Access Compliance Report

Public Rights-of-Way

(Curb Ramps)

Intersection ID: 10527	Main Street: PARKWAY_AV	Cross Street: TUCKASEEGEE_RD	Location: SE
ADA ID: 426231B6A2AA	Ramp Type: Perp	Initial Pass/Fail: Pass	Overall Compliance: No
Severity Score: 2.75			
Codes/Mitigation Info/Possible Solution		Field Measurements/Component Compliance

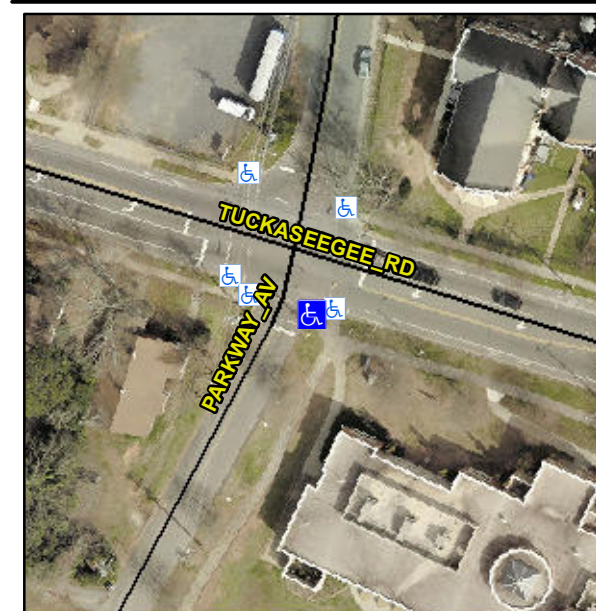
**Not Found, R304.5.3, R304.2.2-Perp,
R304.3.2-Para, R305.1.4**

Compliance	Description	Data	Compliance	Description	Data
N/A	Ramp Length (in)	75.0	Yes	Ramp Slope (%)	7.1
Yes	Ramp Width (in)	55.0	No	Ramp XSlope (%)	3.4
Yes	Flare Type L	Curbed_NoWalkSurface	Yes	Flare Type RT	N/A
Yes	Flare Slope LT (%)	N/A	N/A	Flare Slope RT (%)	N/A
N/A	Flare Traversable LT?	No	N/A	Flare Traversable RT?	No
Yes	Landing Length (in)	48.0	Yes	DWS Provided?	Yes
Yes	Landing Width (in)	62.0	Yes	DWS Contrast?	Yes
No	Landing Slope (%)	2.6	Yes	DWS Length (in)	24.5
No	Landing X Slope (%)	2.4	No	DWS Full Width?	No
N/A	Landing Curb? (Y/N)	No	Yes	DWS Offset (in)	0.0
N/A	Shared Landing?	Yes			
Yes	Gutter Ponding?	No	Yes	Gutter Slope (%)	2.4
Yes	Gutter Lip Ht (in)	0.0	No	Gutter X Slope (%)	3.4
N/A	Painted X Walk1?	Yes	N/A	Painted X Walk2?	N/A
	X Walk 1 Direction	To NW		X Walk 2 Direction	N/A
N/A	X Walk 1 Width (in)	111.0	N/A	X Walk 2 Width (in)	N/A
	X Walk 1 Slope (%)	7.0		X Walk 2 Slope (%)	N/A
	X Walk 1 X Slope (%)	2.1		X Walk 2 X Slope (%)	N/A

Yes	Ramp inside XWalk1?	Yes	N/A	Ramp inside XWalk2?	N/A
	Road Slope (%)	N/A	N/A	Clear Space?	Yes
	Road X Slope (%)	N/A	N/A	Clear Space to XWalk (in)	N/A
Yes	Any Obstructions?	No	Yes	Storm Grate/Utility Hazard?	No
	Obstruction Type			Storm Grate/Utility Type	
		N/A			N/A
			Yes	Surface Condition? (G/P)	Good

**Remove & Replace Entire Ramp.
Remove & Replace Gutter.**
